CRYSTAL RIVER UNIT 3

**ANP-3195(NP), REVISION 0,
RESPONSES FOR CRYSTAL RIVER UNIT 3 EPU LICENSING
AMENDMENT REPORT NRC REACTOR SYSTEMS BRANCH
REQUESTS FOR ADDITIONAL INFORMATION
(NON-PROPRIETARY)**

Responses for Crystal River Unit 3 EPU Licensing Amendment
Report NRC Reactor Systems Branch Requests for Additional
Information

Figure 2.8.5.4.6.1-1 CR-3 HZP BOC w/ Direct Moderator Heating – RCS Pressure

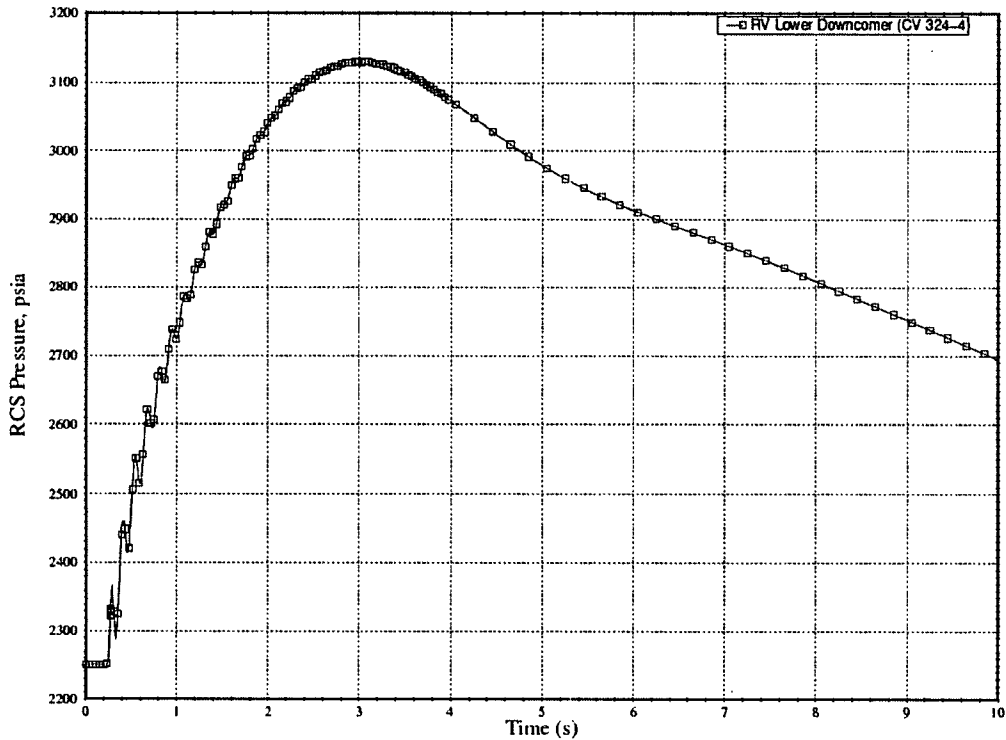
2.8.5.4.6.1 Please provide a plot of pressure vs. time for the pressure-limiting rod ejection event, and explain why there is such a significant pressure excursion.

The plot of pressure versus time for the pressure-limiting event (HZP, BOC, with direct moderator heating) is provided in Figure 2.8.5.4.6.1-1 below.

Due to the rod ejection, the neutron power rises, the power increases and, as the energy in the fuel is transferred to the coolant, the RCS pressure is increased. As discussed in the TR, the over-pressurization analysis assumes no breach of RCS integrity occurs as a direct result of the rod ejection, thereby maximizing the RCS pressure excursion. Moreover, this pressure increase is compounded by the pressurizer surge line diameter.
